UNITED STATES
NUCLEAR REGULATORY COMMISSION
WASHINGTON, D. C. 20555

SUBJECT: BOARD NOTIFICATION REGARDING ISSUANCE OF INTEGRATED (IDI)
REPORT FOR RIVER BEND STATION (BN 84-156)

Docket No. 50-458/84-18

SUBJECT: INTEGRATED DESIGN INSPECTION 50-458/84-18

Figure 4.1-2 Stone & Webster Interdisciplinary flow

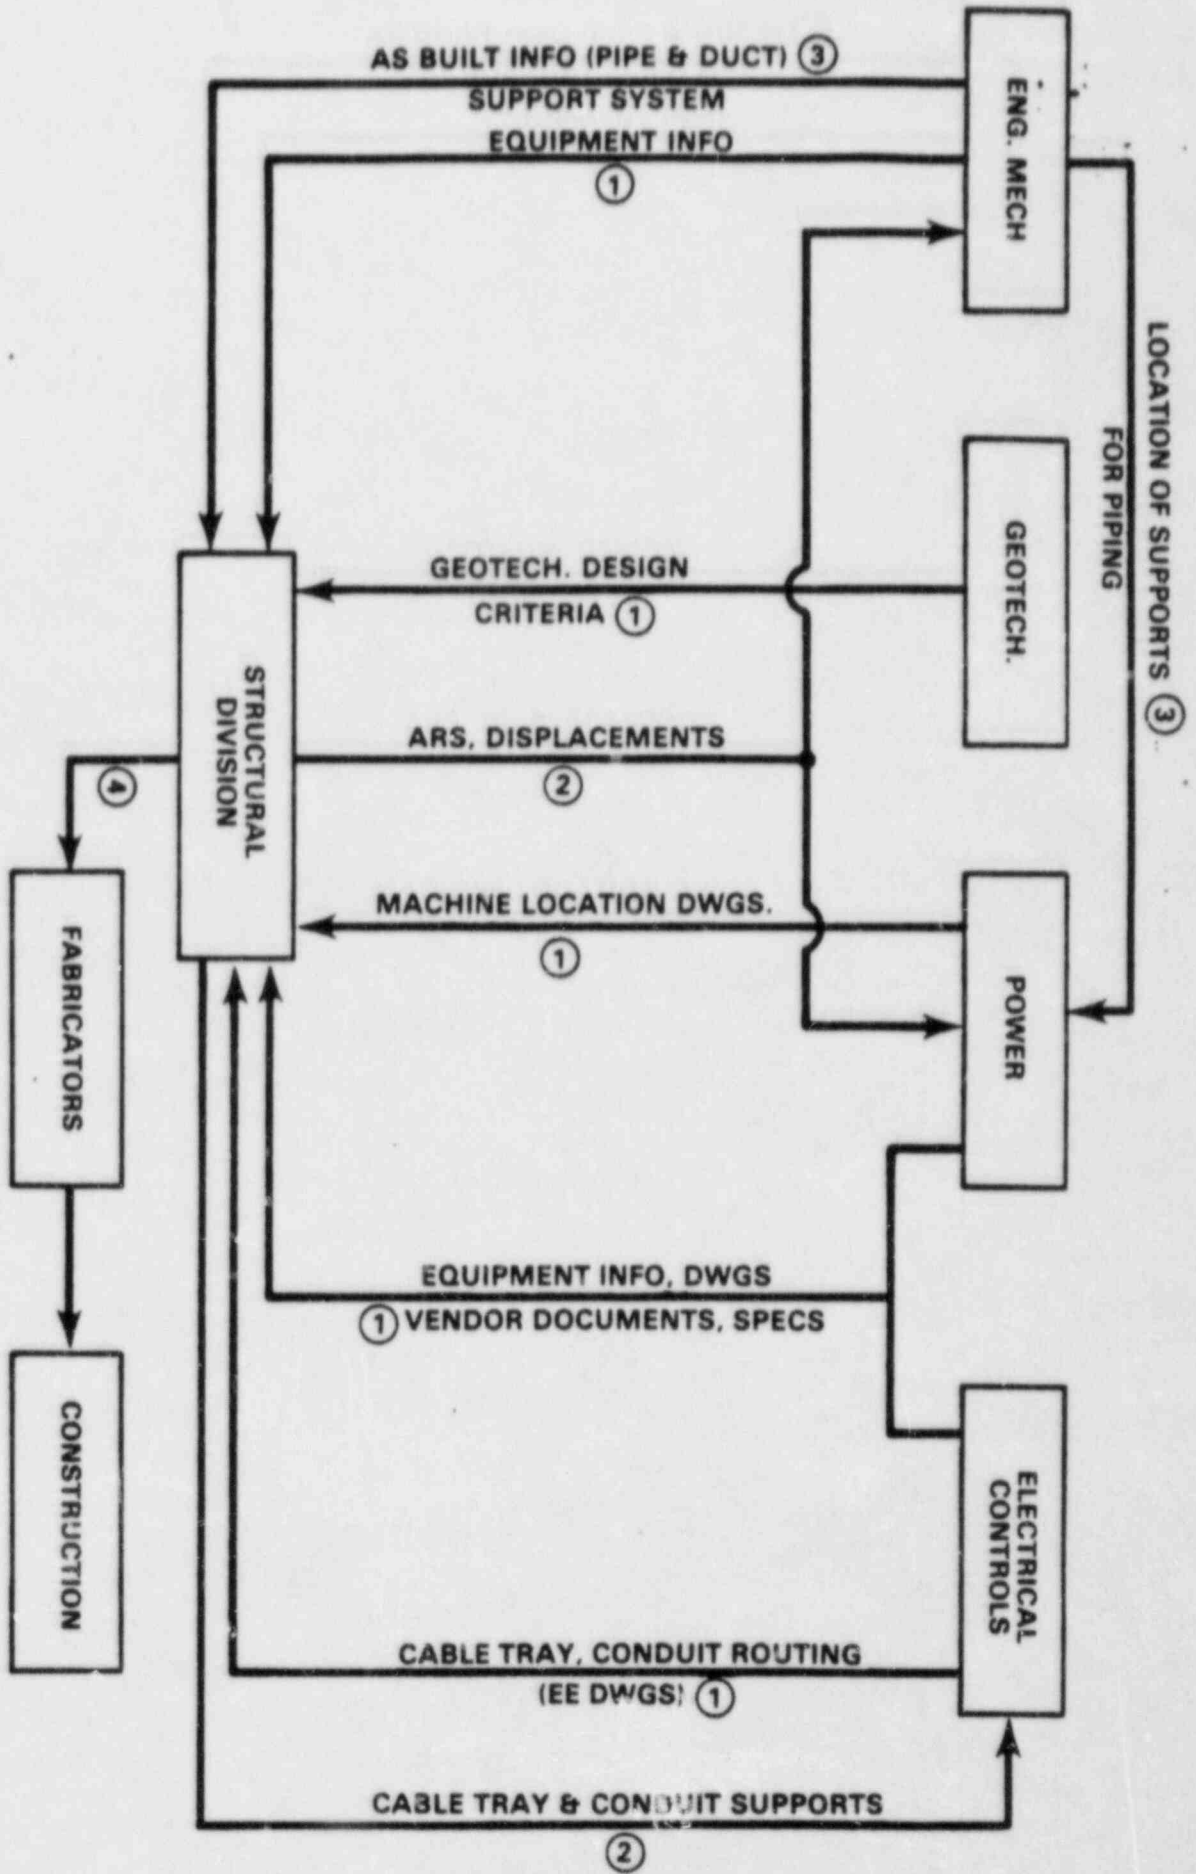
Inspection of the interdisciplinary coordination effort (see Figure F4.1-1) disclosed that design information from various groups such as the Stone & Webster Engineering Mechanics Division, Geotechnical Division, and Power Division are transmitted to the Structural Division. This information is used for the design and proportioning of structural members. The Structural Division Staff Group generates the amplified response spectra and displacements which are forwarded to the various groups. This information is used for the purpose of pipe stress analysis and equipment qualification.

Interfacing between various disciplines with regard to the development of seismic loads was examined (see Detail A4.1-2). The Geotechnical Division develops various design parameters such as soil properties and the Geotechnical Design Criteria. This information is coupled with other design parameters from various divisions including the Structural Division. The Structural Division Staff Group performs the seismic analysis and distributes the information to various divisions. The amplified response spectra and displacements are transmitted to the Engineering Mechanics Division which performs pipe stress and equipment qualification analyses. The forces, bending moments and displacements are forwarded to the Structural Division Project Group which uses this information to perform the structural analysis and design. Results of the seismic analysis are also forwarded to General Electric for the seismic qualification of the nuclear steam supply system.
